1990 Corvette: Service Bulletin: Information on Door Lock System Components and Replacement Components

Bulletin Number: 90-375-10 - (10/25/1990)

Figure 1

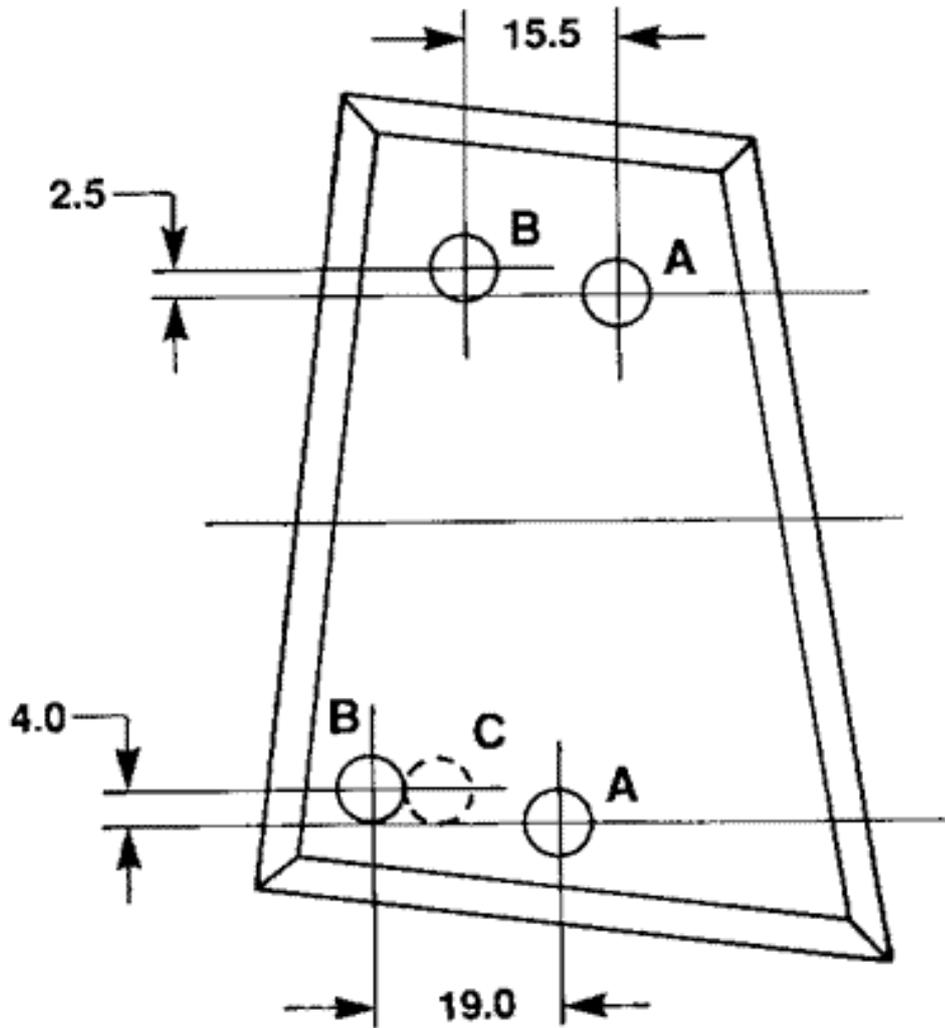
In addition to replacing the above components, it may be necessary to relocate the power door lock actuator on the door inner panel. Figure 1 will illustrate the hole patterns.

- If the actuator is located in the holes marked "A," it will not need to be relocated.

- If the actuator is located in the holes marked "B";
- remove the actuator by drilling out the attaching rivets.
- locate the new attaching holes ("A") using the dimensions on the illustration.
- attach the actuator in the new location using 1/4" X 1/2" peel type rivets.

IMPORTANT: Hole "C" may or may not be present. Relocate holes from "B" locations only.
